# Service Bulletin No. 274B

<b>MODEL</b> D Series Coaches	<b>TYPE</b> Field Change Program	<b>SECTION/GROUP</b> 7 – Electrical	<b>DATE</b> Aug. 16, 2007
<b>SUBJECT</b> BOOST CONNECTOR			
<b>CONDITIONS</b>

**THIS BULLETIN SUPERCEDES FIELD SERVICE BULLETIN 274 IN IT'S ENTIRETY.**

**Figure 1. Existing boost connector.**

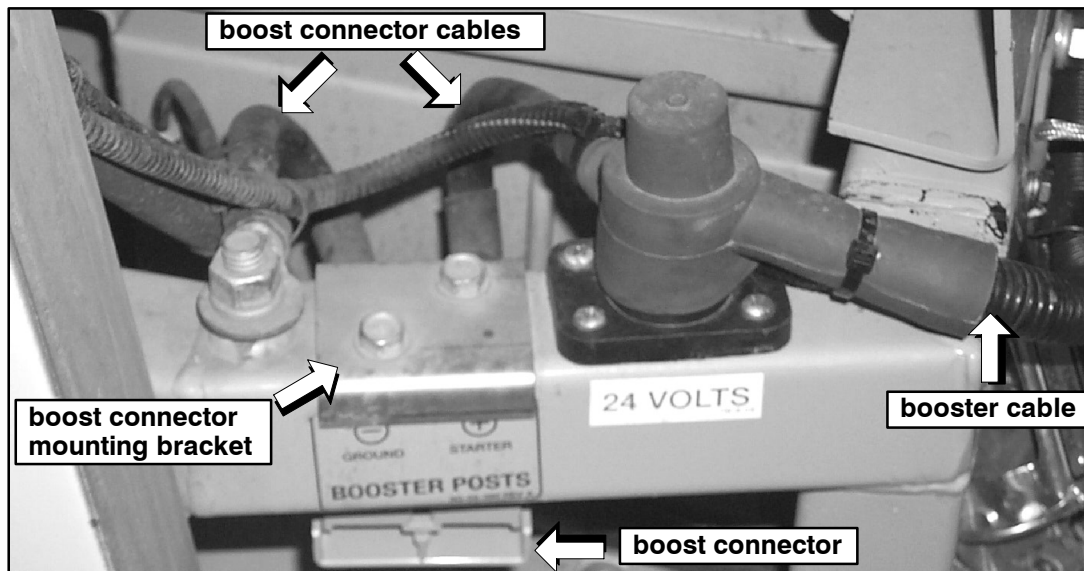
Motor Coach Industries, Inc. ("MCI") has determined that a defect which relates to motor vehicle safety may exist in certain MCI D series coaches that contain a boost connector. MCI has become aware that the boost connector's plastic housing may crack, which can allow the positive and negative leads to come in contact. In rare conditions, this may cause an overheat with arcing, and could result in a thermal event.

2. Open the rear, side service compartment door and locate the boost connector ( Figure 1 ).
3. Clearly identify the existing coach harnesses that are routed to the 24 Volt and Ground booster posts.
4. Remove and retain the nuts, washers, boost connector cables and booster cable from the booster posts.

5. Remove the two capscrews that secure the mounting bracket to the frame. Discard the mounting bracket and the existing boost connector.

10. Align the boost connector cables with the correct polarity booster post ( Figure 1 ). Position the existing coach harnesses and the boost connector cables on the correct polarity booster post, orientated so that the largest diameter ring terminal is on the bottom.
11. Using the two nuts removed in Step 4. , secure the cables to the booster posts.
12. Position the cap on the 24 volt post. Close the rear, side service compartment door.

Figure 2.

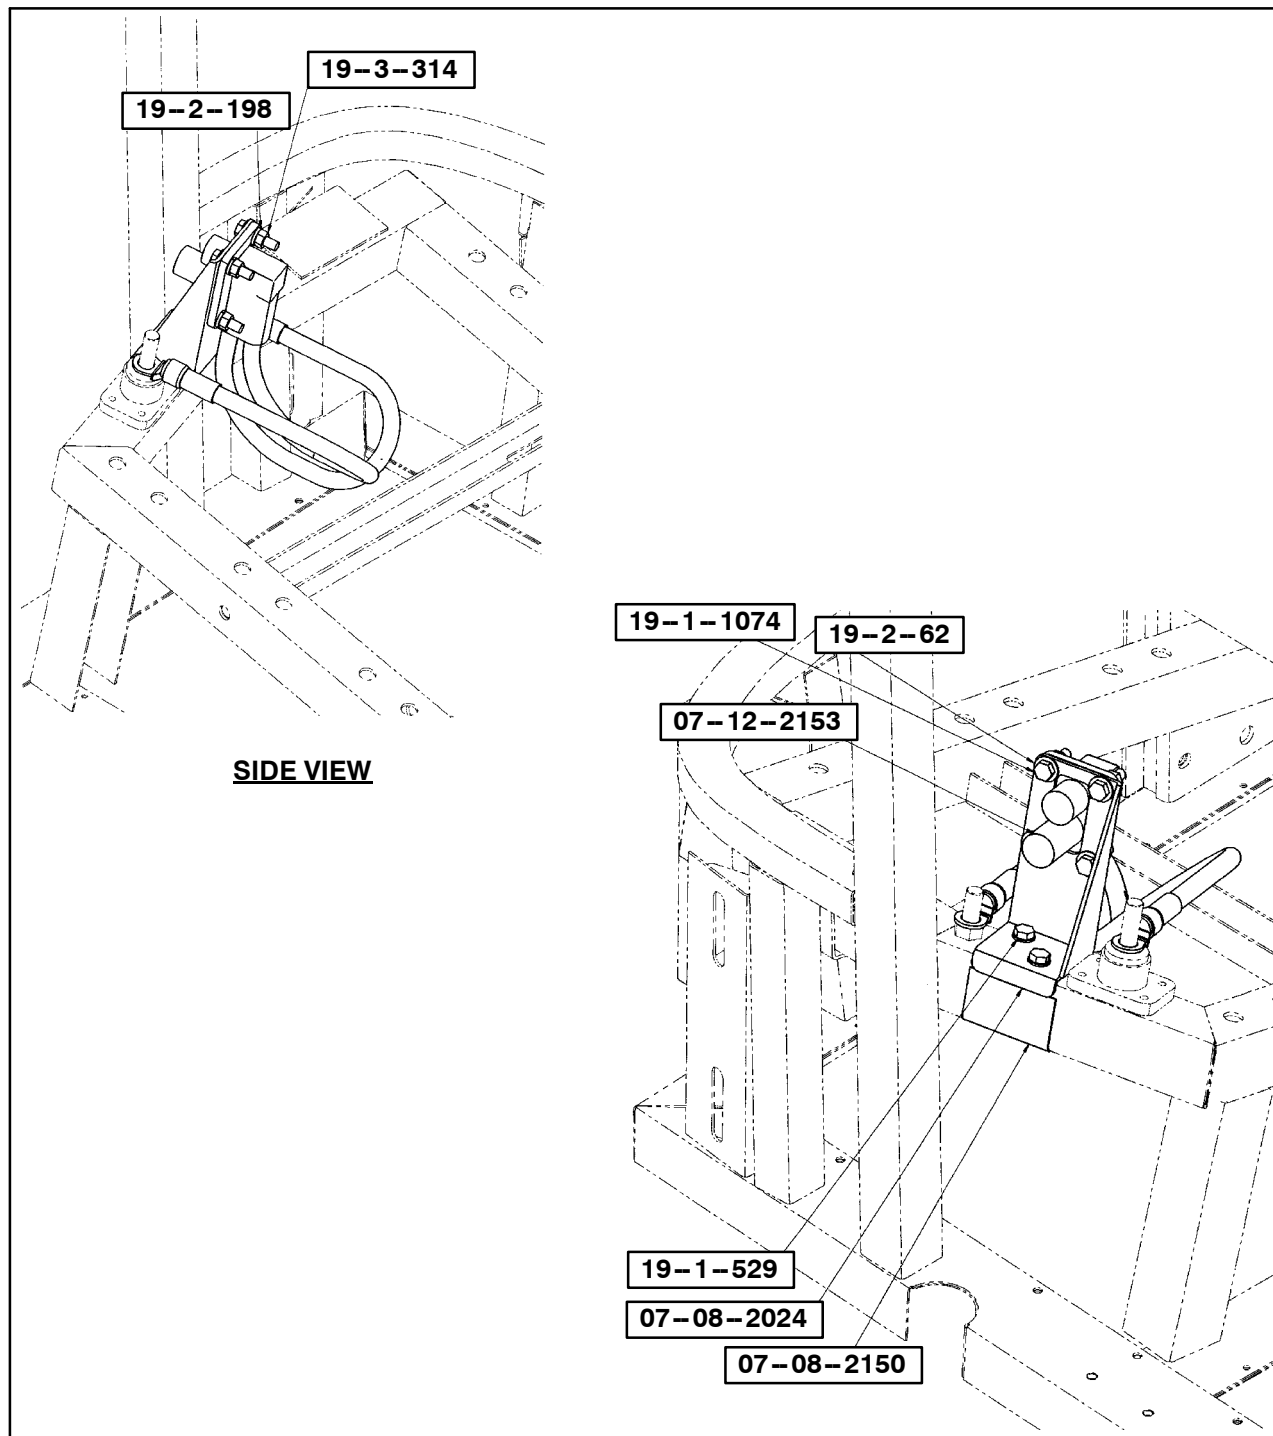
6. Position the mounting bracket ( p/n 07-08-2024 ) on the frame, aligned with existing holes in the frame.
7. Secure the connector assy ( p/n 07-12-2153 ) to the mounting bracket ( p/n 07-08-2024 ) using the hardware provided in the Parts list ( p/n 19-1-1074, 19-2-198, 19-2-62 and 19-3-314 ) ( Figures 2 and 3 ).

Figure 3. Reference photo.

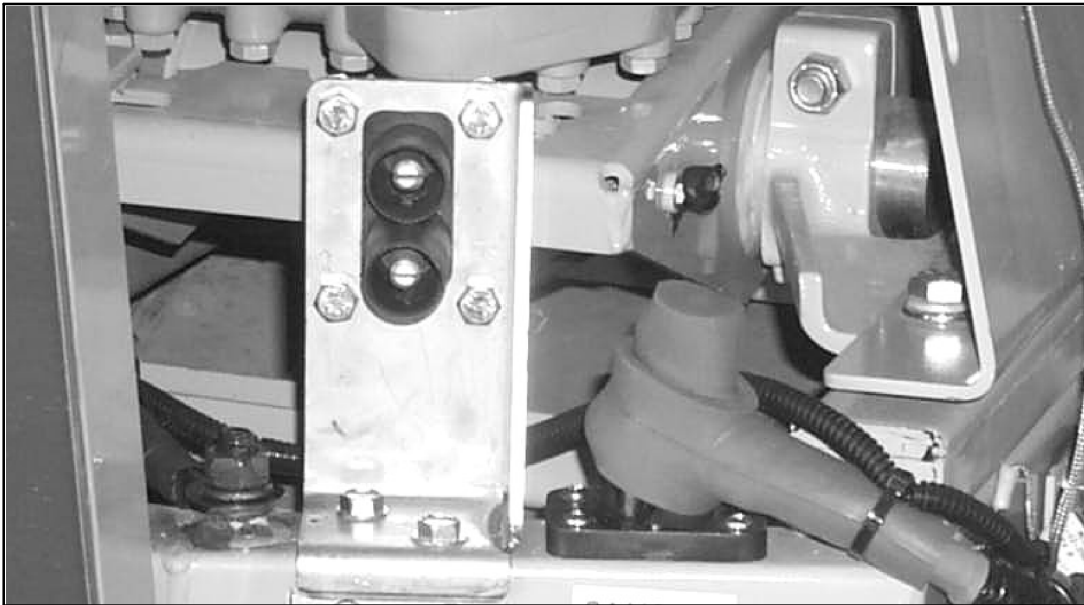
8. Install the booster connector assembly ( mounting bracket ) to the frame and secure the protective cap ( p/n 07-08-2149 ) using two screws ( p/n 19-1-529 ) ( Figures 3 and 4 ).

9. Using a clean cloth and an isopropyl alcohol and water mixture, clean the decal application area shown in Figure 4. Apply the booster posts decal ( p/n 07-08-2150 ).
